BEFORE THE DESIGN REVIEW COMMISSION  
OF THE CITY OF ASTORIA

IN THE MATTER OF DESIGN REVIEW REQUEST )  
)  
FOR THE FOLLOWING PROPERTY: MAP T8N R9W ) **ORDER NO. DR21-01**  
SECTION 7CC, TAX LOT 3500; LOTS 34, 35, 36; BLOCK B )  
TAYLOR; 432 W. MARINE DR., ASTORIA OR 97103 )  
)  
ZONES: C-3 (GENERAL COMMERCIAL) AND UTO )  
(UNIONTOWN OVERLAY) )  
)  
APPLICANT: PORTWAY STATION LLC, CHESTER )  
TRABUCCO, 990 ASTOR STREET, ASTORIA, OR 97103 )

## STAFF REPORT AND FINDINGS OF FACT

SUBJECT: DESIGN REVIEW REQUEST (DR21-01) TO CONSTRUCT A BUILDING AT  
432 W MARINE DRIVE

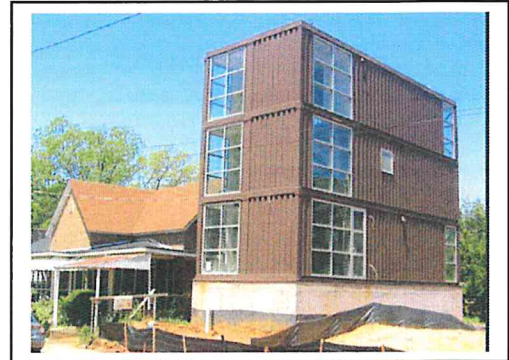
This photo shows the visual impact of three stacked cargo units (with a foundation) adjacent to a 1.5 story building. The proposed project would be three tall, two deep, and two wide adding to the overall mass of the structure.

With the elimination of the pop-up, the City finds that the overall height / scale of the building is still higher and more massive than the adjacent structures.

Appearance without pop-up

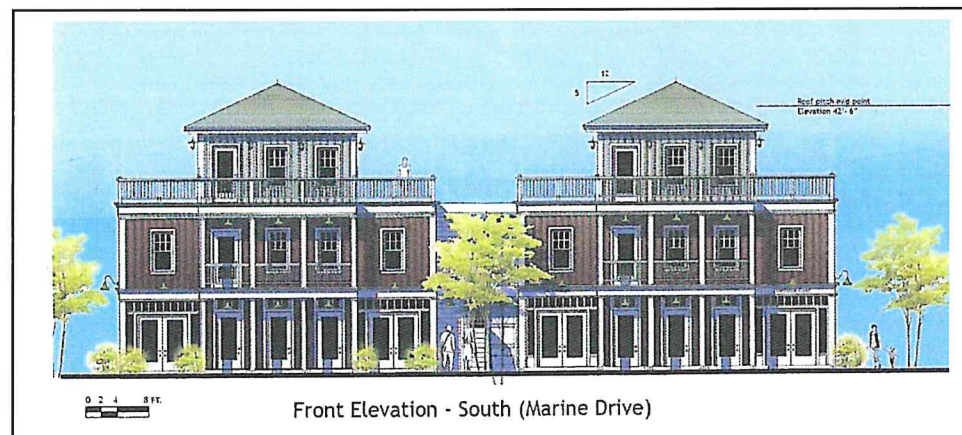
If the building were reduced to two floors with or without the pop-up, the height / mass / scale of the building would be compatible with the other structures within the three-block visual corridor. Therefore, based on the above discussion, the City finds that the building shall be reduced to two floors with or without the pop-up (Condition 5).

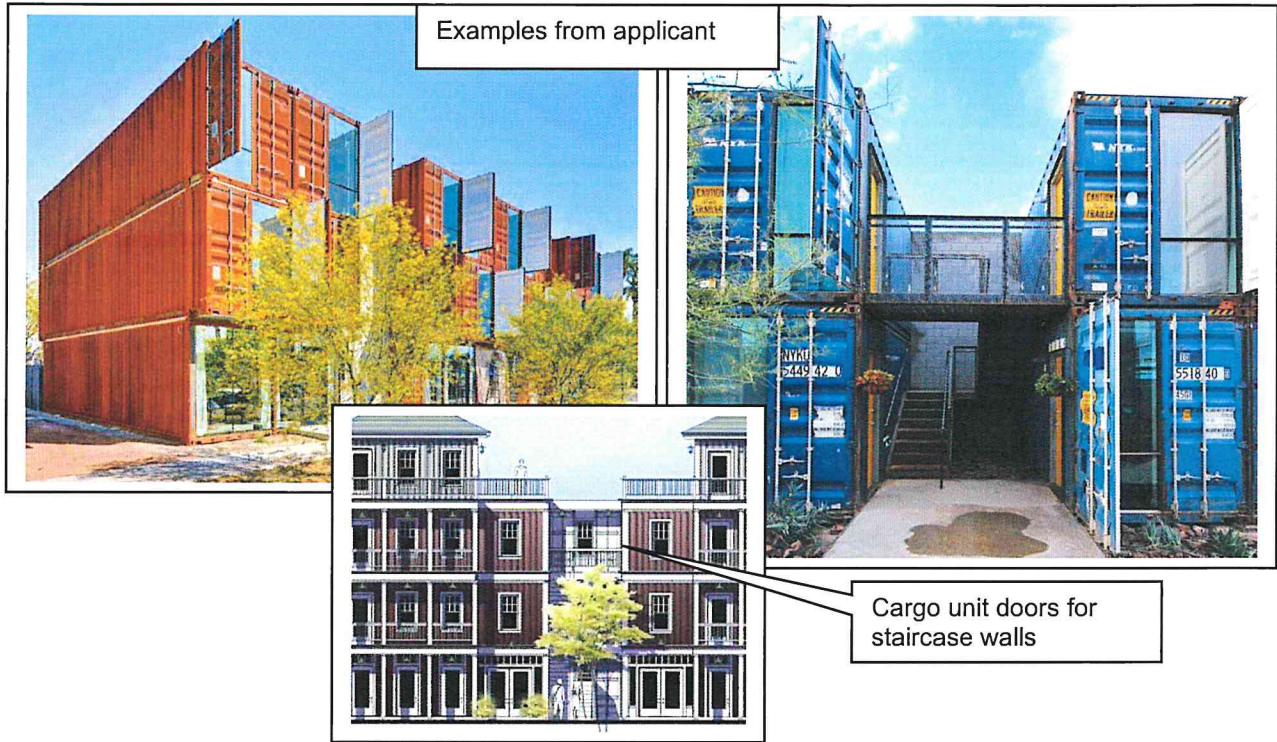
The applicant has submitted a board and batten design option which would be compatible as not all buildings in a historic streetscape need to have horizontal siding. The DRC finds that the Port area has metal buildings and that the metal ribbed cargo container units would respect the metal and wood composition of the neighborhood streetscape.

The walls of the central staircase would be the cargo container unit doors with existing cargo door locking hardware remaining. The cargo doors shall be painted to remove the shipping and other printed information on the doors (Condition 2).

Therefore, the City finds that if the doors are painted to remove the shipping and cargo unit information (Condition 2), the staircase walls would respect significant characteristics of composition and material of adjacent structures that are visible from the public right-of-way within three blocks of the development site
